**RE: 6421 Dennison Rd SW
Grading & Drainage Plan
Engineer's Stamp Date: 03/14/24
Hydrology File: K11D096**

GRADING & DRAINAGE PLAN

Clark Consulting Engineers Edgewood, New Mexico 87015		Tele: (505) 281-2444	Cell: (505) 264-6042
DATE	REVISION	LOT 6, BLOCK 'B', ALAMOSA ADDITION ALBUQUERQUE, BERNALILLO COUNTY, NEW MEXICO 6421 DENNISON RD, SW MUNOZ RESIDENCE Grading & Drainage Plan	
DESIGNED BY: PWC	DRAWN BY: COE	JOB #: Rafael_Dennison	1 OF 1
CHECKED BY: PWC	DATE: 3/20/24	FILE #: G/D

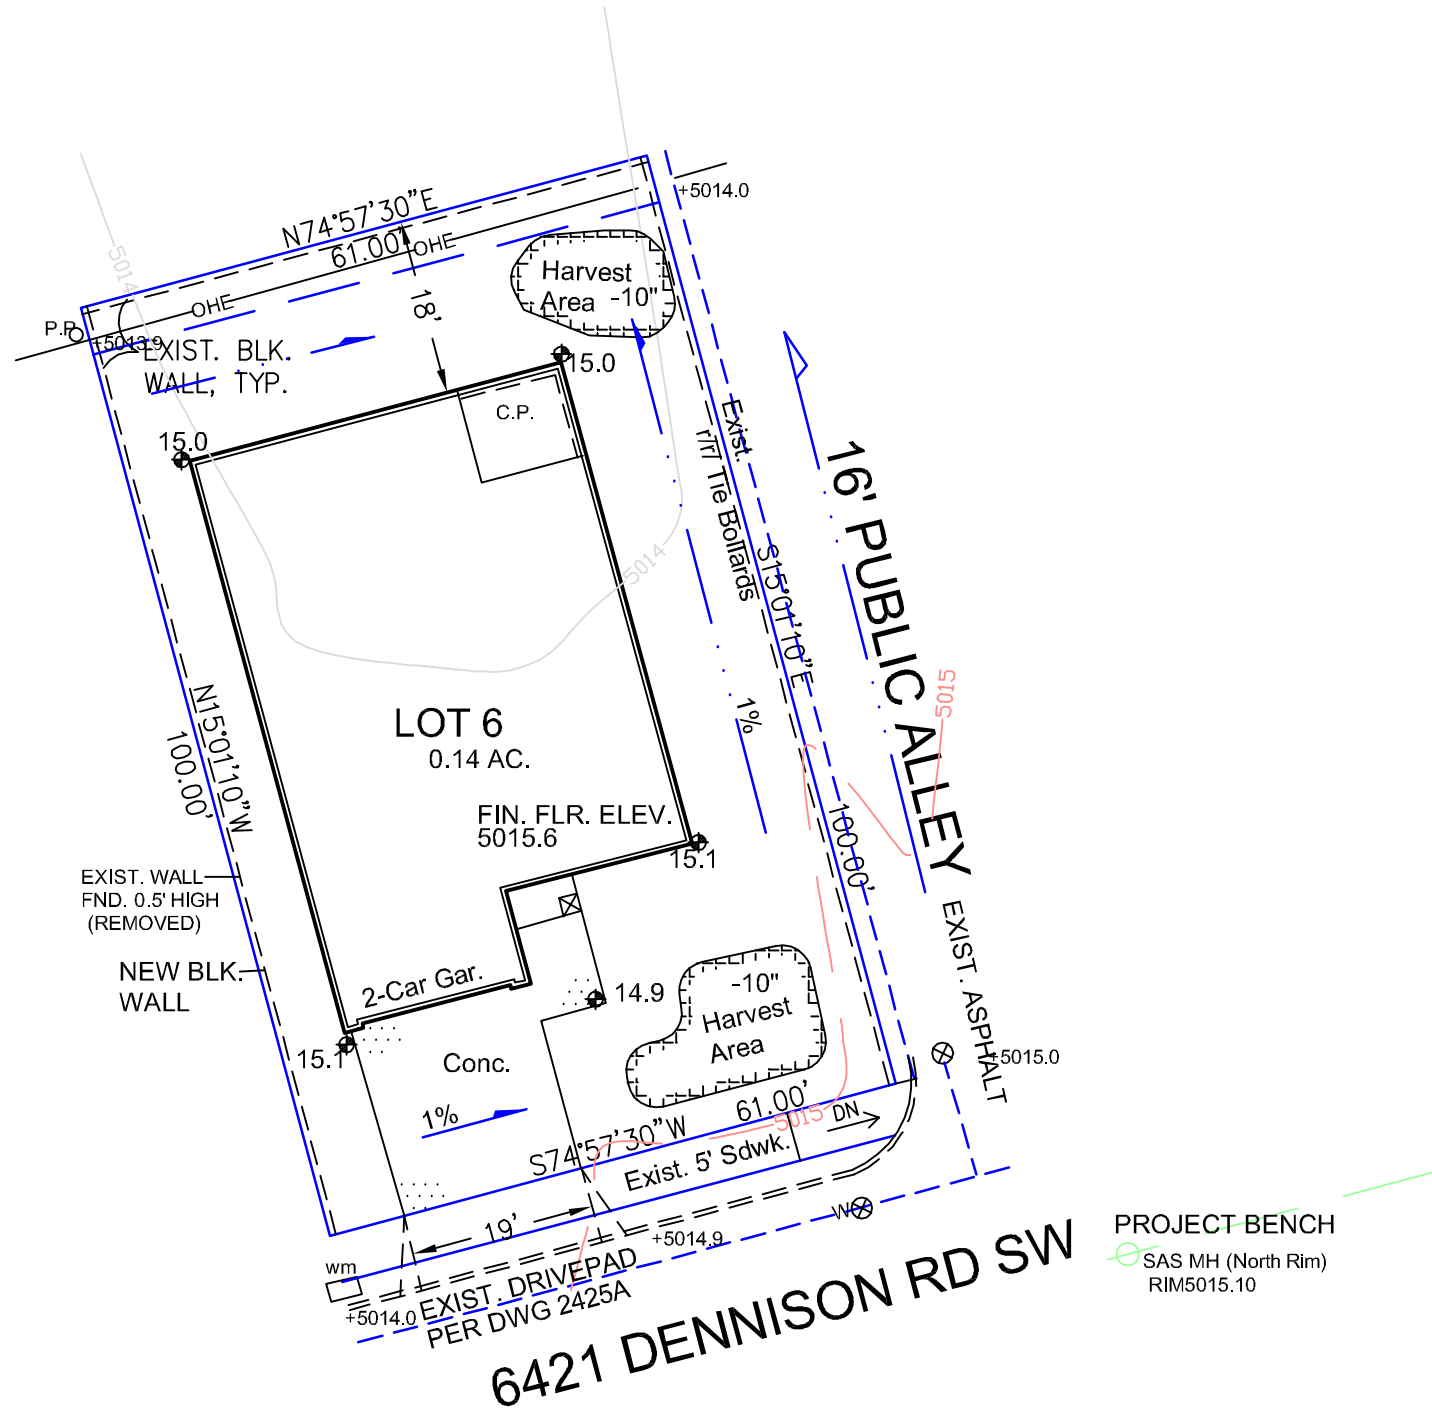
Based upon the information provided in your submittal received 03/28/2024, the Grading and Drainage Plan is approved for Building Permit and Grading Permit. **Since this site is relatively flat and grades to the road, a pad certification is not needed for this project.** Please attach a copy of this approved plan in the construction sets for Building Permit processing along with a copy of this letter.

1. Engineer's Certification, per the DPM Part 6-14 (F): Engineer's Certification Checklist For Non-Subdivision is required.
